ULNRC- 04574

**DOCKET NUMBER 50-483
CALLAWAY PLANT
UNION ELECTRIC COMPANY
PROPOSED REVISION TO TECHNICAL SPECIFICATIONS 3.9.4
"CONTAINMENT PENETRATIONS"; 3.3.6 "CONTAINMENT PURGE
ISOLATION INSTRUMENTATION" AND 3.3.7 "CREVS ACTUATION
INSTRUMENTATION"
TO ALLOW OPEN CONTAINMENT EQUIPMENT HATCH
DURING REFUELING OPERATIONS**

ATTACHMENT 2

TABLE 16.3-2 (Continued)
ENGINEERED SAFETY FEATURES RESPONSE TIMES⁽¹¹⁾

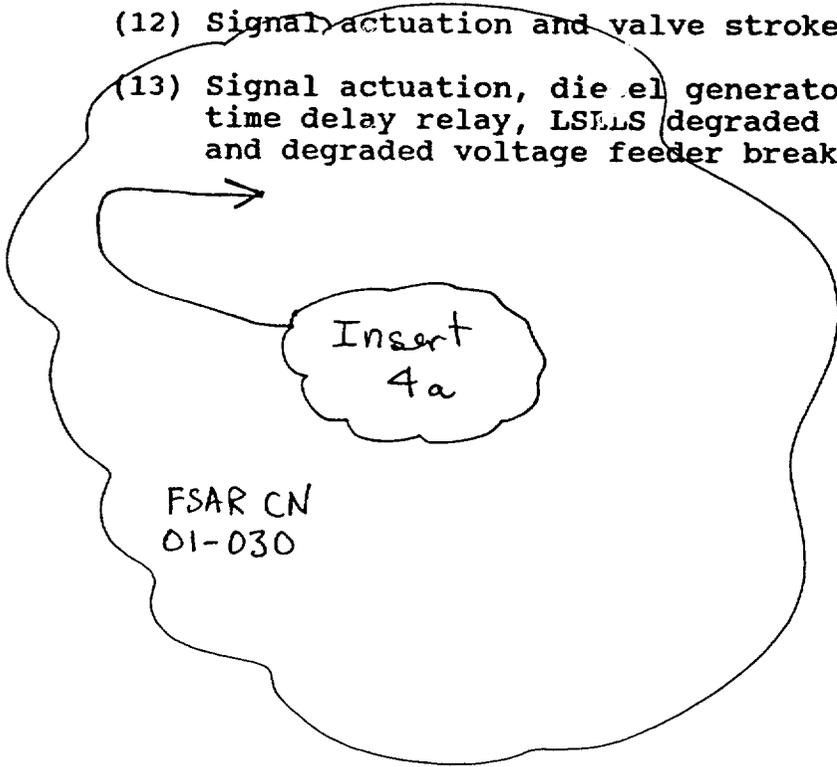
INSERT 4a

(14) The radiation monitor detector is excluded from response time testing. The stated response time accounts for the elapsed time between introduction of a count rate from the detector corresponding to the actuation setpoint and repositioning of the components necessary to achieve Control Room isolation.
